AMENDMENT OF SOLICITATION/
MODIFICATION OF CONTRACT

NASA/Goddard Space Flight Center
GOES Procurement Office, Code 214.2
Greenbelt, MD 20071

Hughes Space and Communications Co.
PO Box 92919
Los Angeles, CA 90009

X 10A. MODIFICATION OF CONTRACT/ORDER NO.
NAS5-9806910B. DATED (SEE ITEM 13)
01/28/98

Figure 5.3.2-2 Maximum Allowable Electronics Module Random Vibration Level Inputs from the Spacecraft

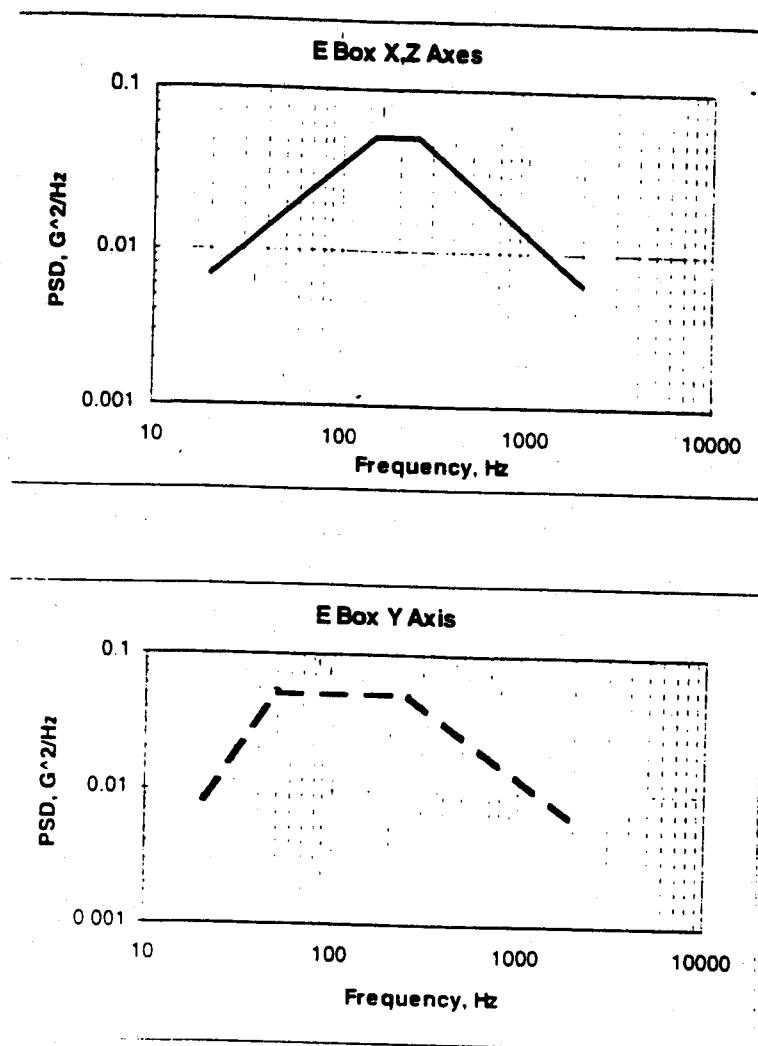
Correct table 5.3.2-3, figure 5.3.2-2 and figure 5.3.2-3 to reflect the revised random vibration levels for the Electronic Module and Power Supply as indicated in the attached pages.

CHANGE TO:

Figure 5.3.2-3 Maximum Allowable Power Supply Module Random Vibration Level Inputs from the Spacecraft

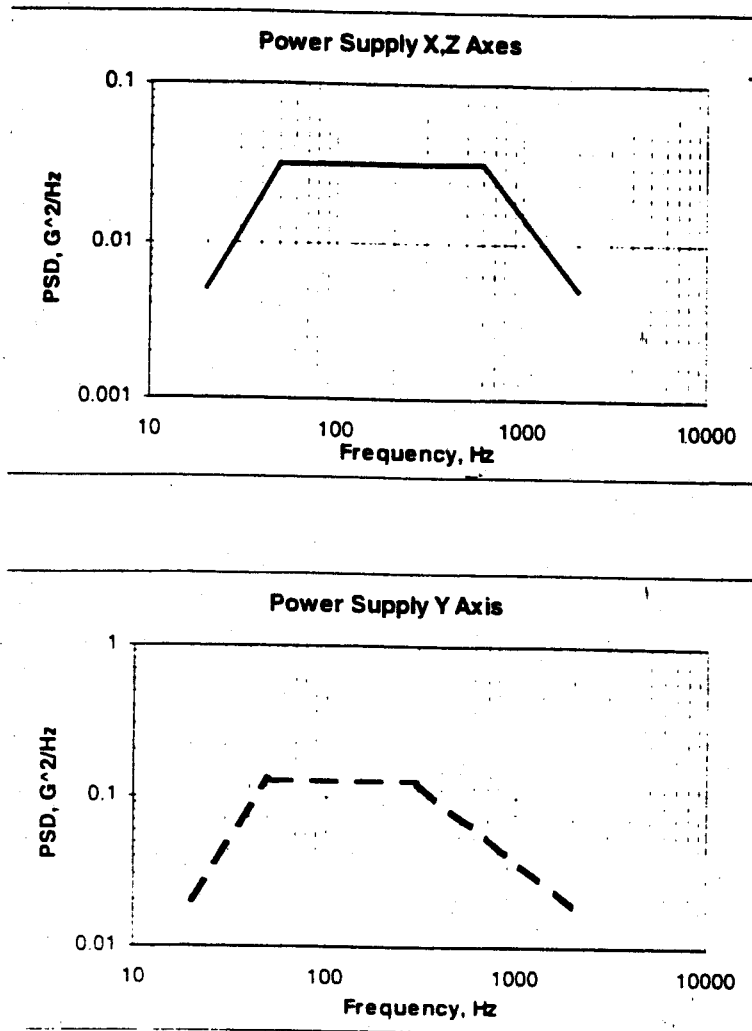
Correct table 5.3.2-3, figure 5.3.2-2 and figure 5.3.2-3 to reflect the revised random vibration levels for the Electronic Module and Power Supply as indicated in the attached pages.

CHANGE TO:
